# **Attachment 7**

**Public Comments  
Received after  
posting for the  
March 2, 2022  
Public Hearing**

## 2.1 Lodestar Master Plan – Maximum Building Heights

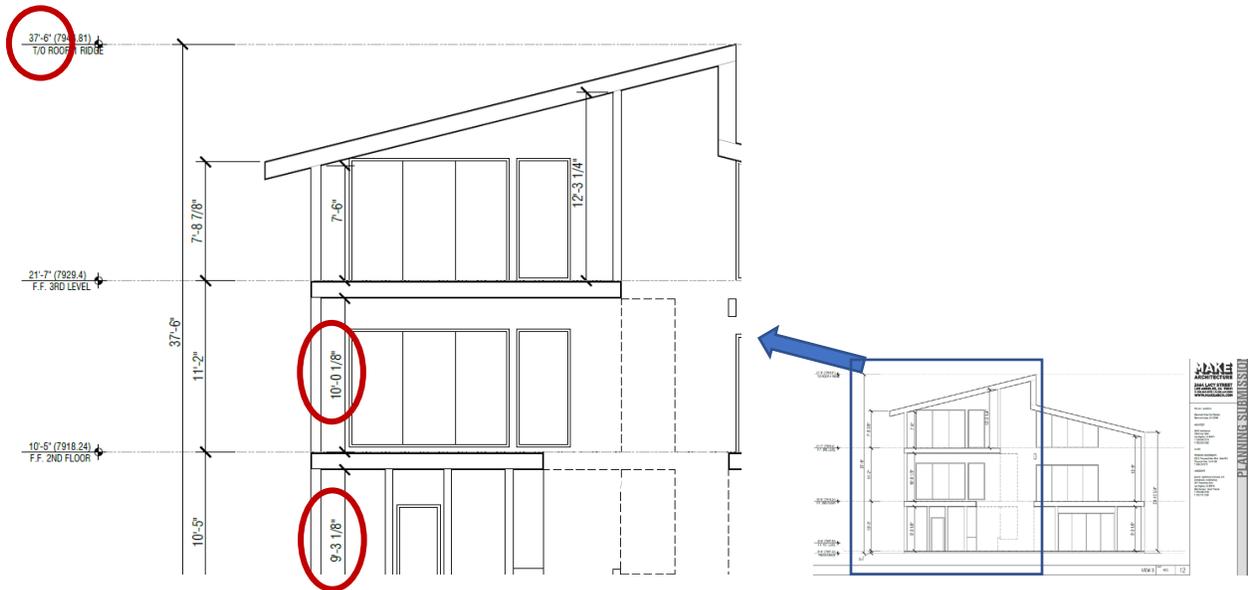
I strongly object to the proposed height ADJUSTMENT 21-006. The Lodestar Master Plan states clearly that the maximum permissible building height is 35 feet for Development Areas 1, 2, 3, and 4. [ATTACHMENT 2.1]

## 3.1 SAFER BUILDING DESIGN 3:12 ROOF PITCH

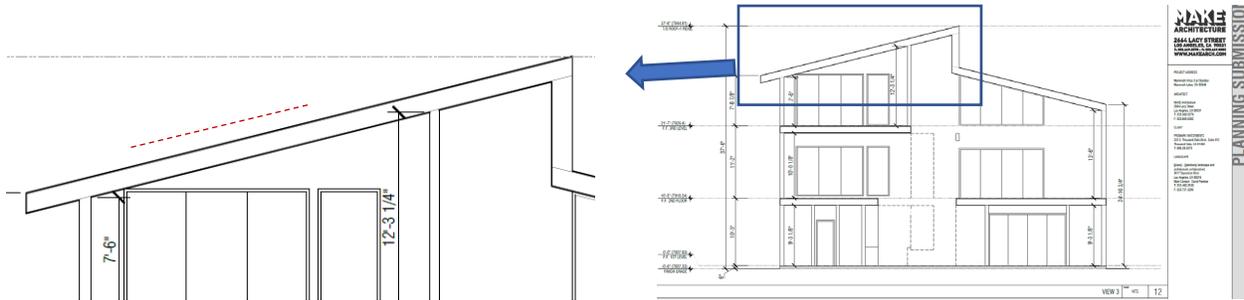
The requested Height Adjustment 21-006 states that the increased height “will result in increased safety of the occupants by allowing for a 3:12 roof pitch.” (Resolution pg. 6 of 178; ATTACHMENT 3.1). I agree that a 3:12 slope in Mammoth Lakes is safer than a 1.5 :12 slope. Why is this 3:12 safety standard not consistently applied to the duplex roofs that show in the Project Plans have just 1.5 :12 slope? [ATTACHMENT 3.2 – 3.3].

## 3.3 DUPLEXES = 1.5 :12 ROOF PITCH

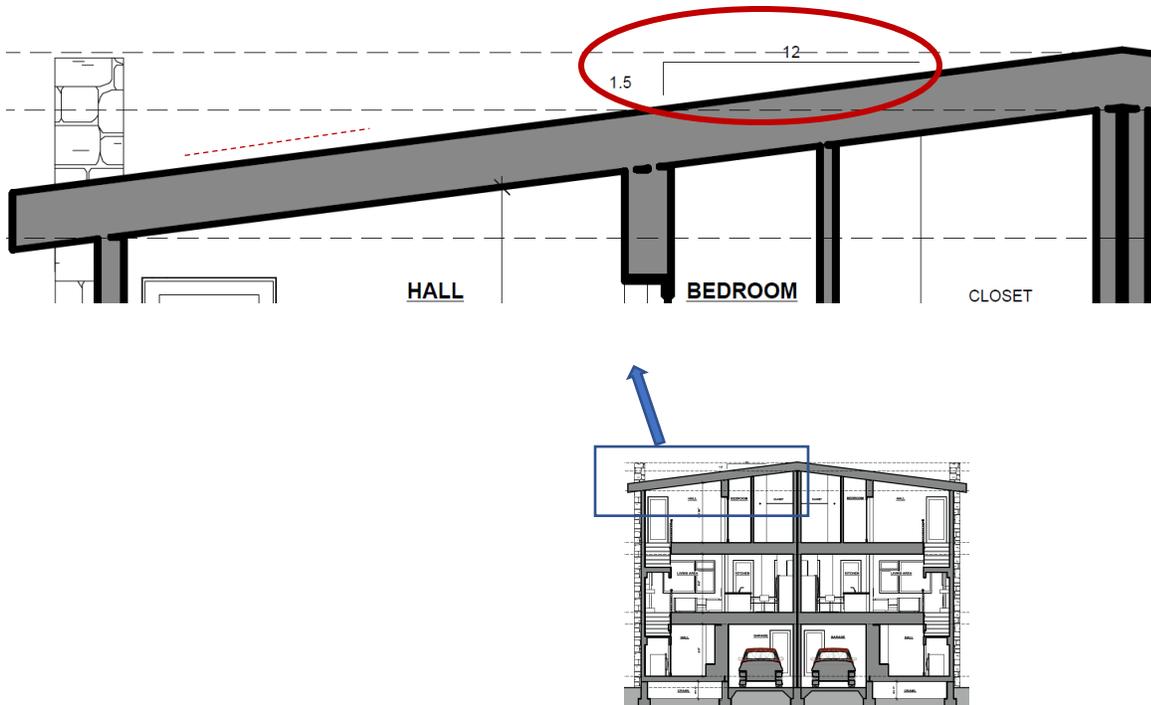
- R3. Evidence and an explanation for why a 3:12 is needed for the homes, but only a 1.5 :12 slope is needed for the duplexes.
- R4. Evidence that the 1.5 /12 slope on the duplexes is adequate for safety of both the inhabitants and SJV Building E.
- R5. Evidence that the 1.5 /12 slope on the duplexes, and units 22-25 specifically, will not cause snow to pile up on the roofs, decreasing estimated sunlight even further.

## 4.1 Existing EASEMENT being Vacated for Villas III

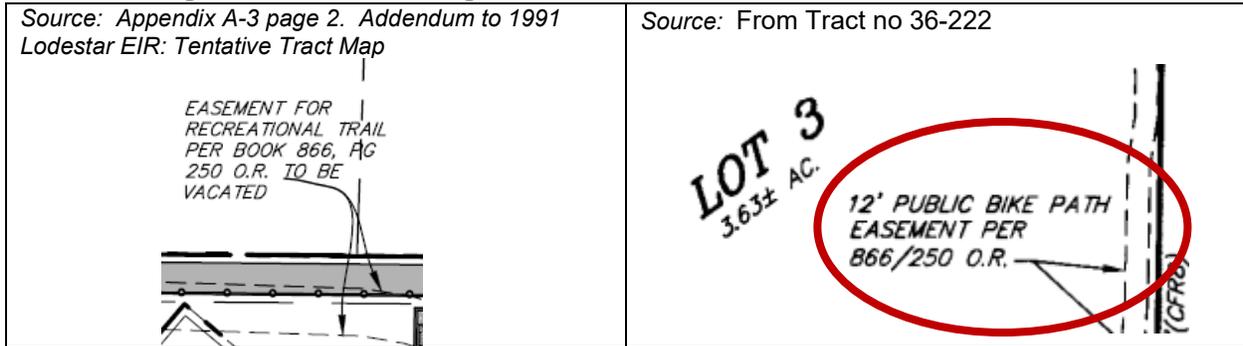
The Tract Map shows that the Villas III development seeks to remove an existing section of the Town Loop Trail and construct a new trail on the eastern edge of the development with a smaller easement. In essence the private Villas III development plans to absorb a portion of the existing MLTS easement, and MLTS has been funded by tax initiative Measure R.

## 4.2 Villas III Proposed Reduction to Existing 12' Easement to 11.5'

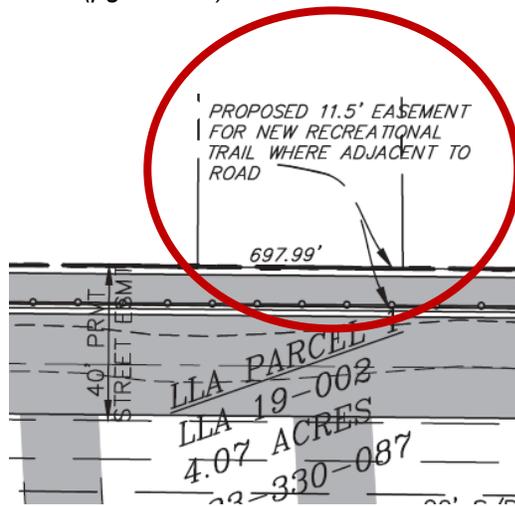
Despite the update the inconsistency remains; a 12' easement is being vacated (ref. TM 36-222 sheet 3 of 4, Lot 3); **TTM 21-001 must be updated to provide a 12' easement for the entire length.** Without the update the development will absorb a portion of the easement of the MLTS.

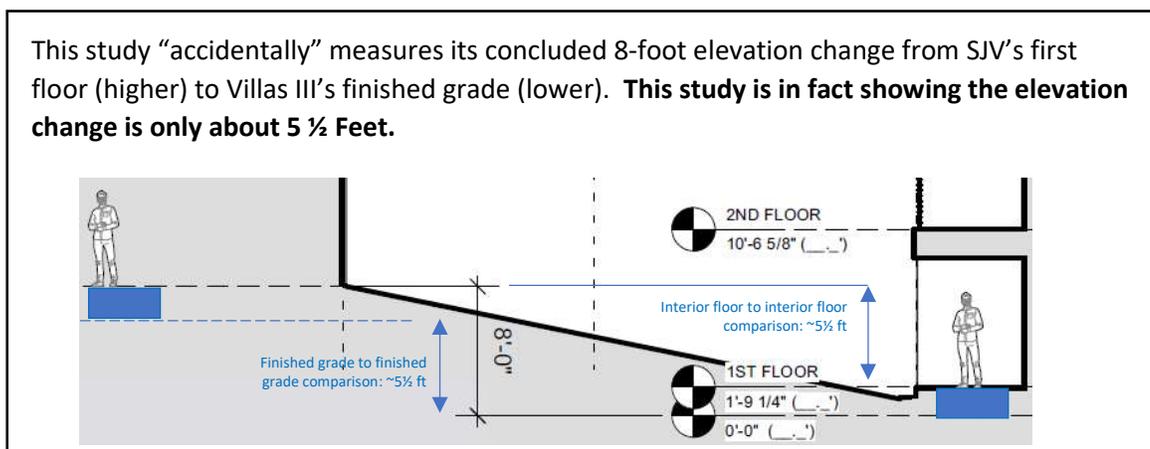
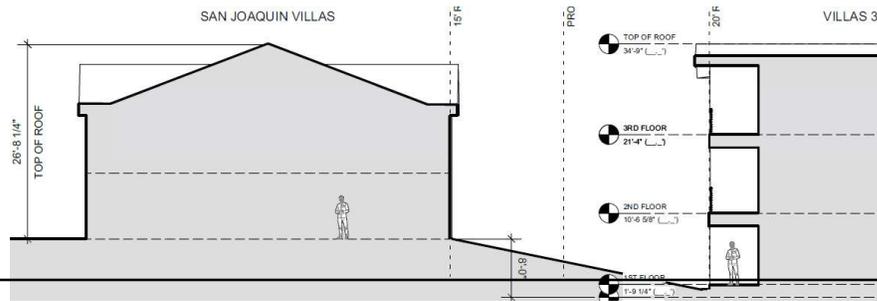
Additionally, this study **misrepresents the relative height** between the SJV E-building and Villas III duplexes by using inconsistent reference points between the two structures. Maximum building height is measured from the finished graded adjacent to the building exterior to the highest roof peak. This “study” does not use “apples-to-apples” references. Both structure heights should be measured from finished grade (indicated by horizontal blue dashed line on SJV image, and the zero-reference on the Villas III image).

By misrepresenting both the SJV image proportion and the incorrect height reference point, this “study” attempted diminish the actual impact of the Villas III duplex 35-foot height.

This “study” also misrepresents the relative **Heights** of the SJV E Building and the Villas III duplexes (p. 69/74). It shows the tops of the 2 buildings to be the same height. It claims SJV is 26’- 8 ¼” and Villas III is 34’ - 9” tall. The actual difference in height would be 8’-3 ¾”. However, the previous paragraph proves that the Elevation Change is actually about 5.5’. Their error is almost 3’ in height, which is an **error of more than 10% relative to SJV’s height**.

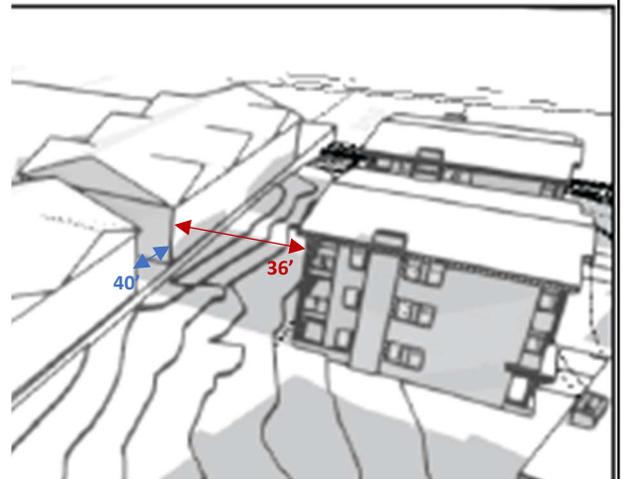
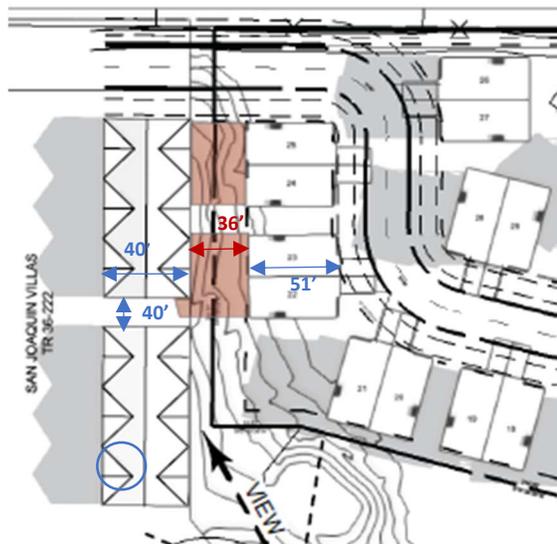
The **distances between buildings** are also misrepresented, as can be seen by the images below with the actual dimensions applied.

The distance between Villas III and SJV E-building (36’) is shown inaccurately as significantly larger than the distance between SJV’s E- and D-buildings (40’).

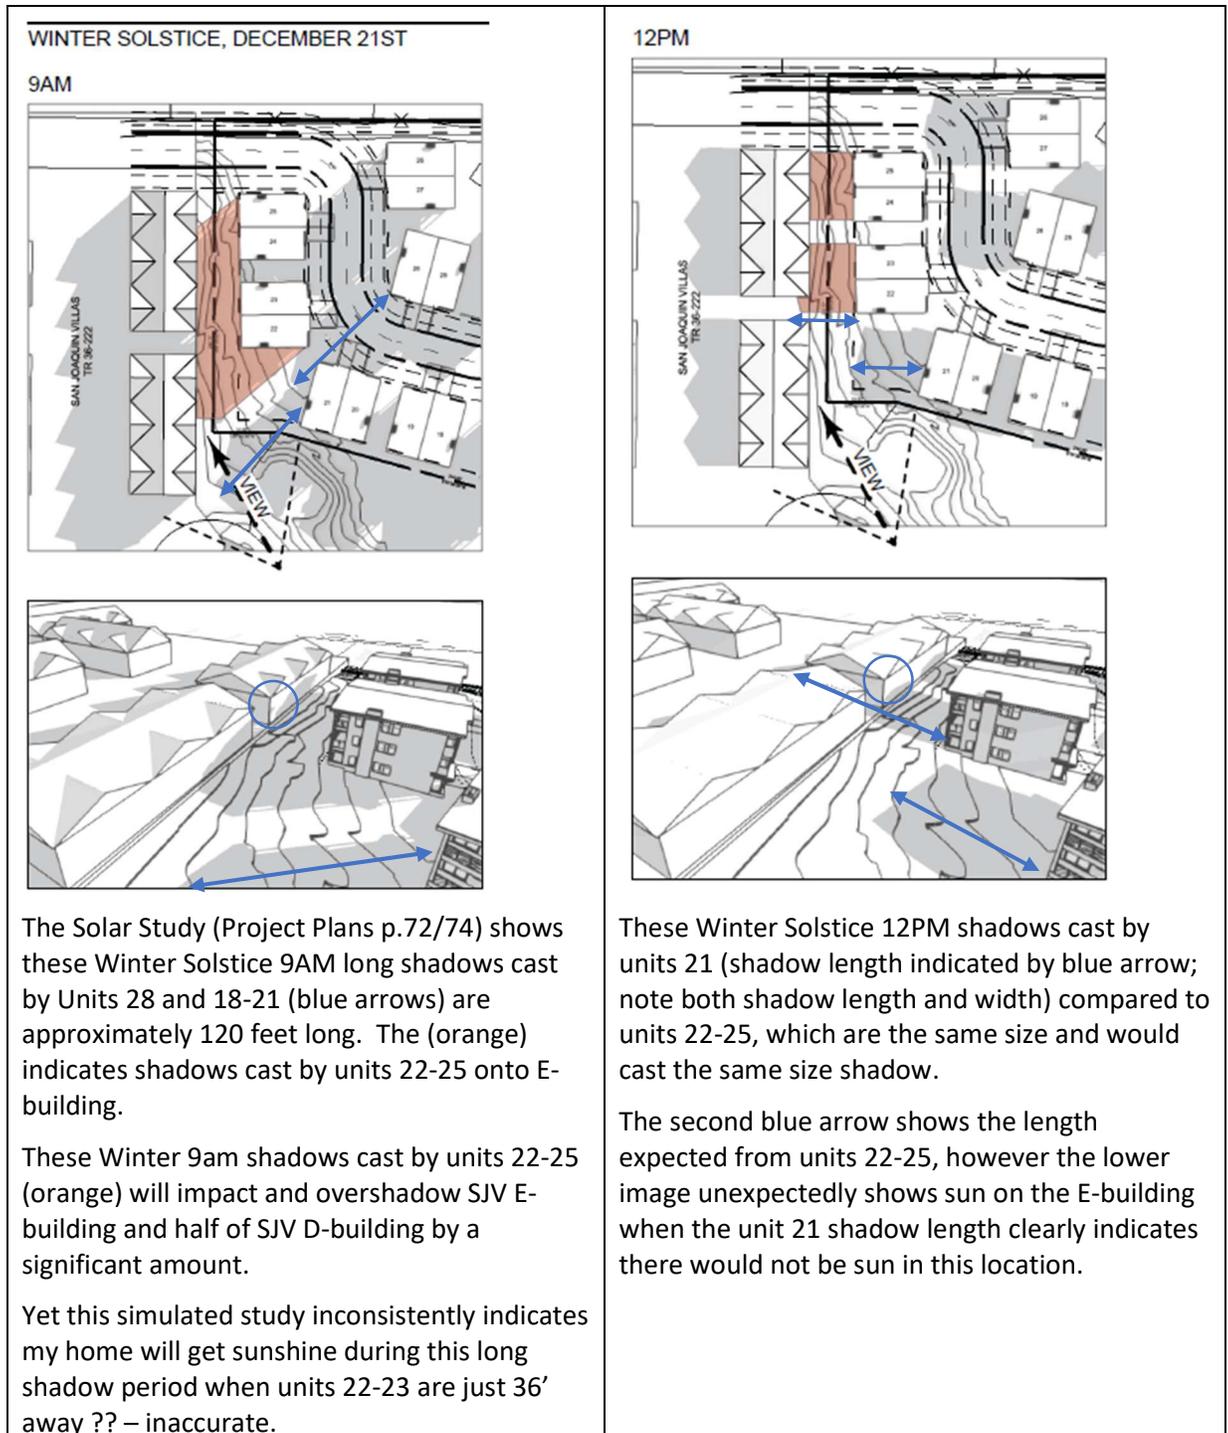
Further, these same “study” pages illustrate the significant size of the duplex shadows cast by the other duplex units and yet try to minimize that effect when the shadow strikes the SJV E-building.

The Staff Report 2022-03 Figures 10-12 (pp 8-10) and Attachment 2 Project Plans (pp . 69-74) fail to use actual building dimensions of either the Villas III Duplex units 22-25 or San Joaquin E-building. By using **unmistakably incorrect building proportions**, the developer has deliberately fabricated a scenario that provides a false impression of lessening the negative impact of building shading on SJV E-Building during the winter months than the true reality.
